DeYOUNG SUBDIVISION Construction Drawings El Paso County, Colorado

PCD PROJECT NO. MS-20-001

TITLE SHEET

SHEET: **G2**

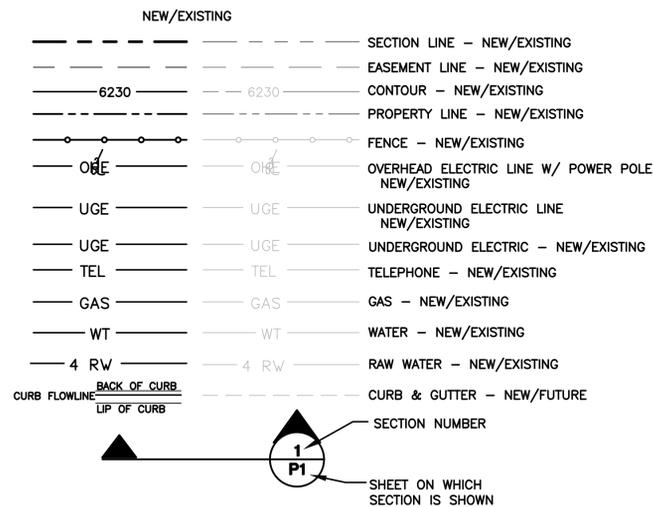
Include cul-de-sac area.

PHASE 1 - SITE GRADING & EROSION CONTROL PLAN

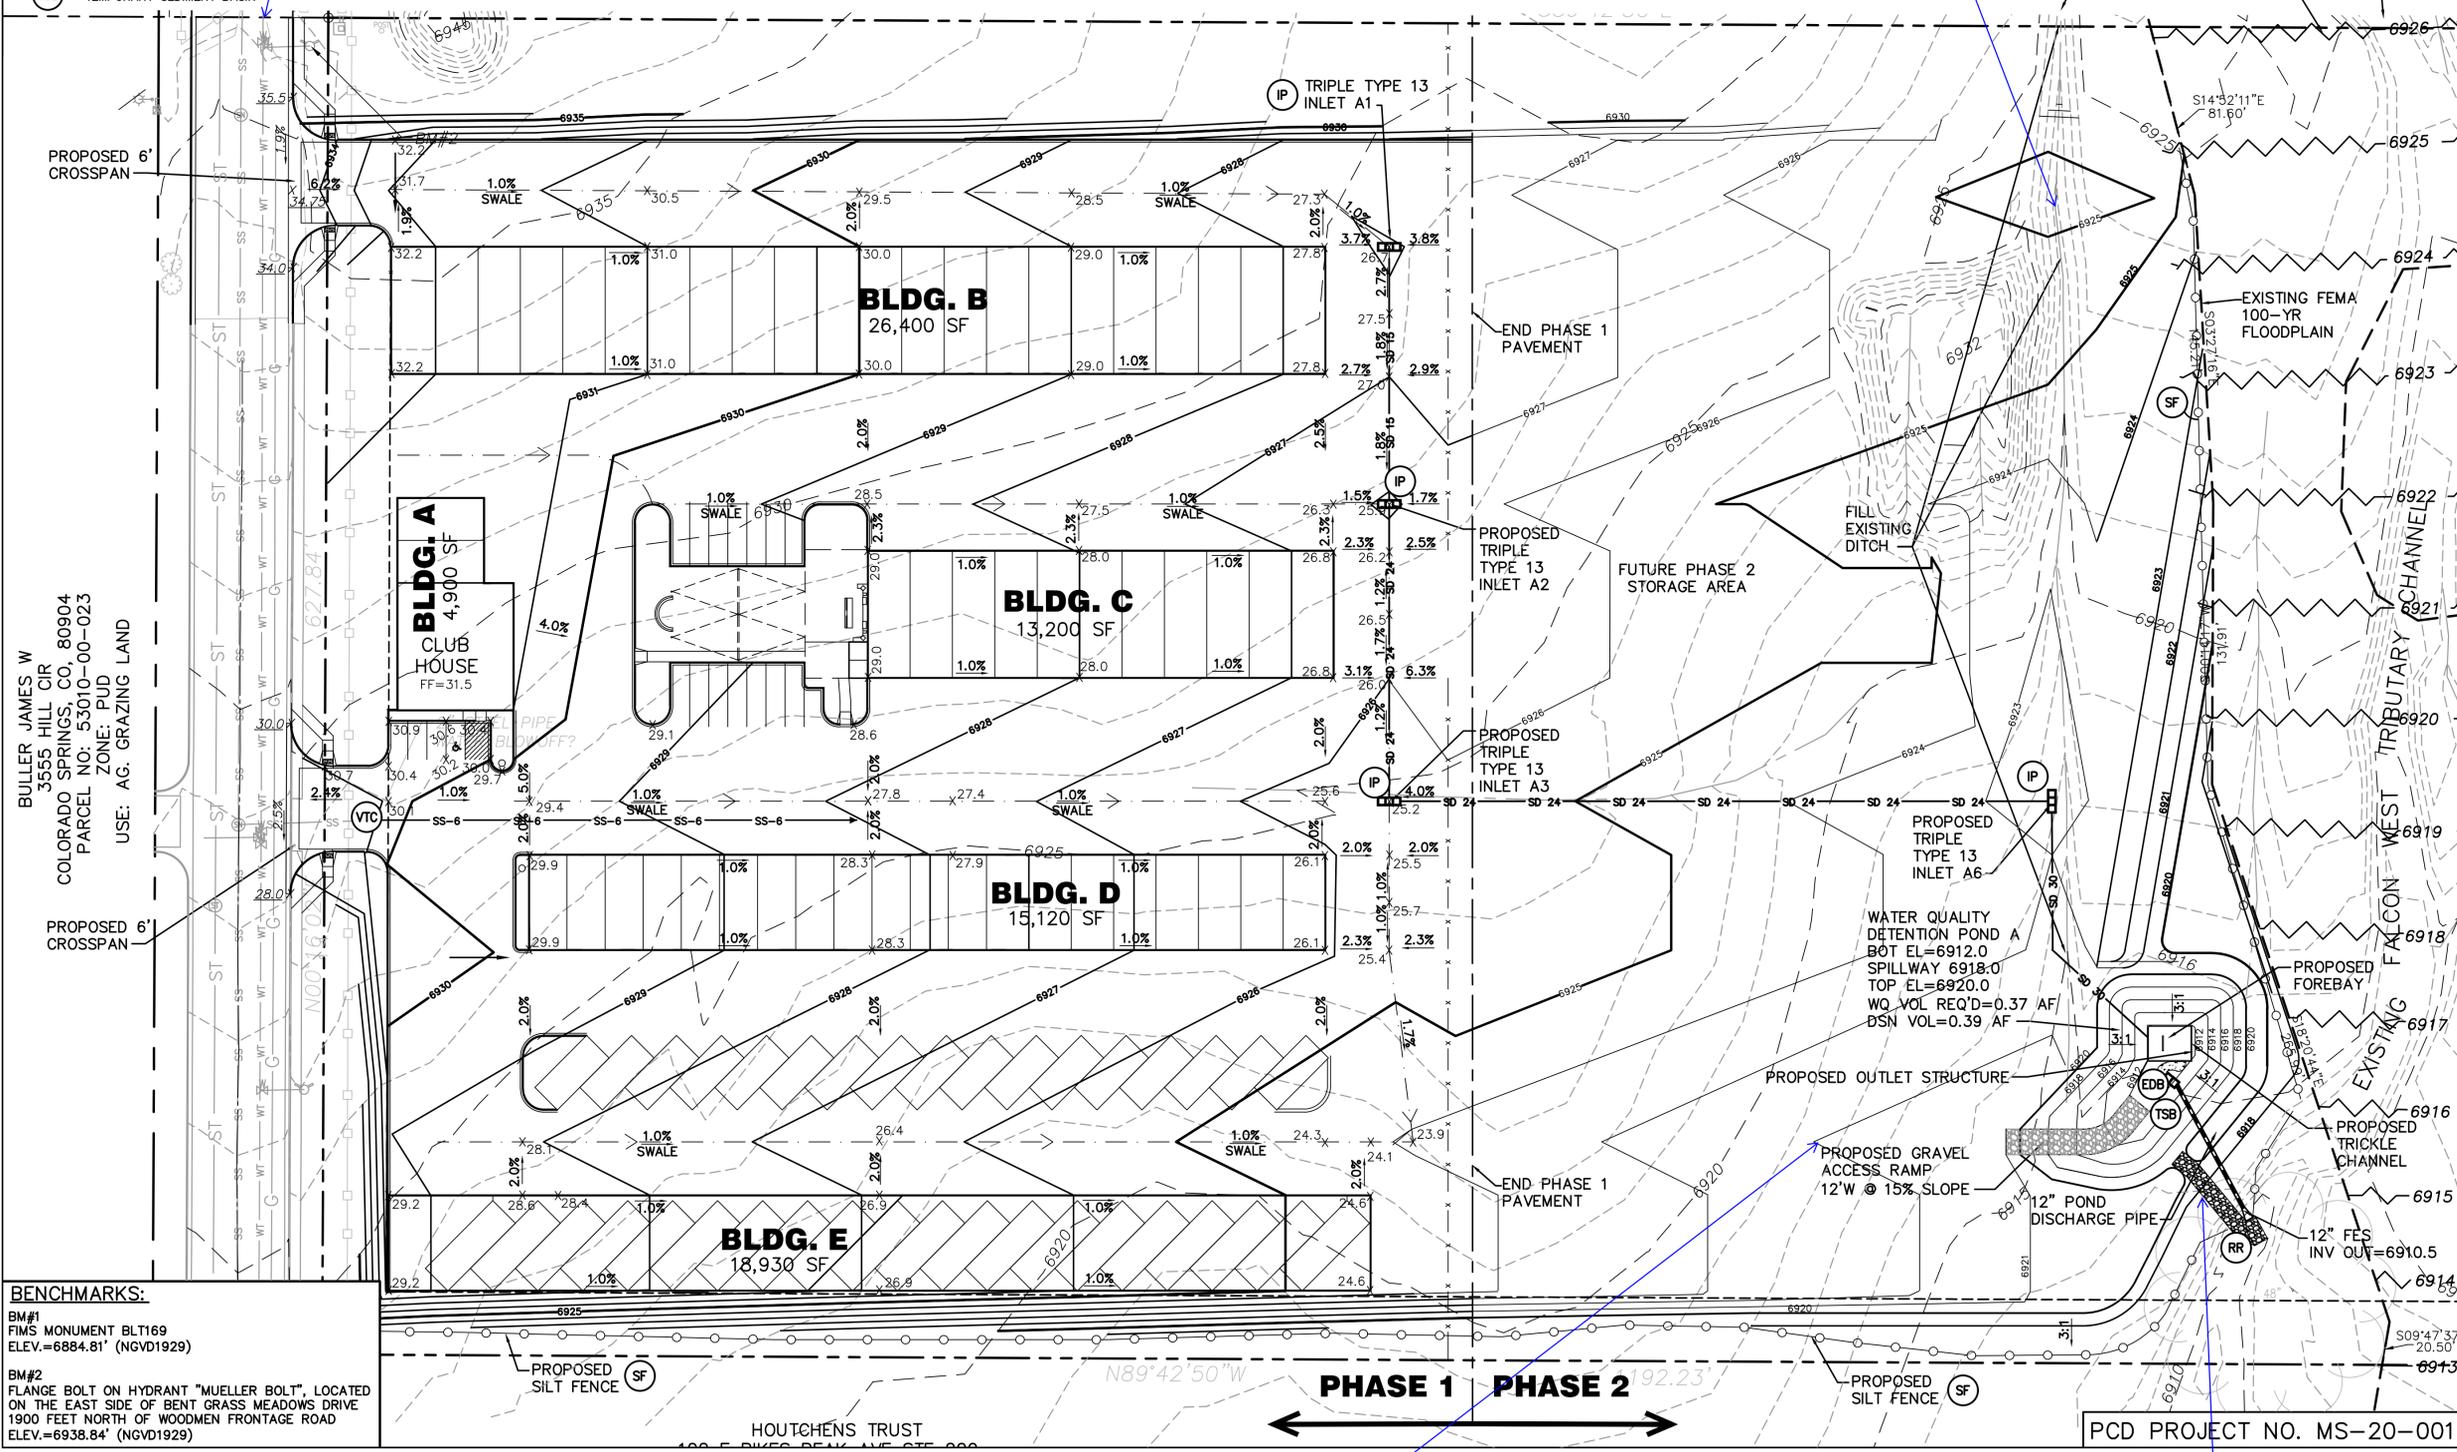
How does this area drain? Is it a TSB?

See comment on the drainage report concerning this drainage swale.

See comments on CD sheet regarding spillway.

DETENTION POND A
PLAN & DETAILS

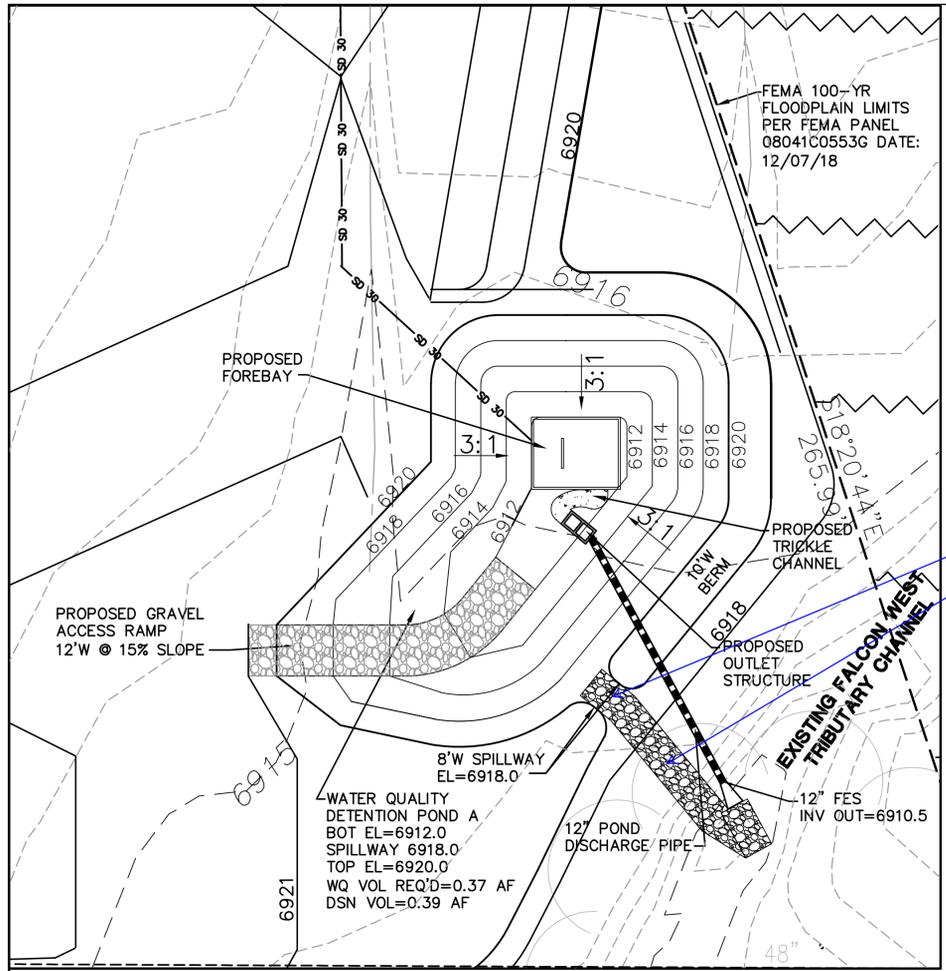
Provide cross-sections across the spillway at the top and midpoint showing dimensions and 100-year depth. This will be regularly overtopping for storms releasing over ~6 cfs based on the outlet pipe and restrictor size; additional detailing of the spillway and channel protection is required. A check structure (potential drainage fee offset) may be required in the channel to prevent headcutting upstream from the new point discharge location.

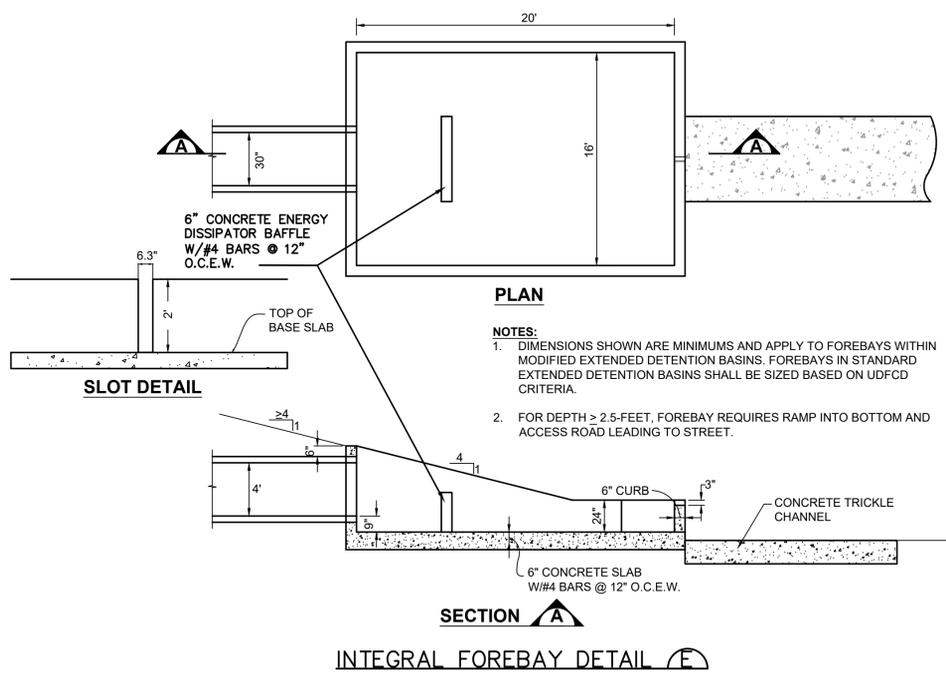
The drainage report indicates 2.83 square inches for the outlet orifices, these slots appear to be too large.
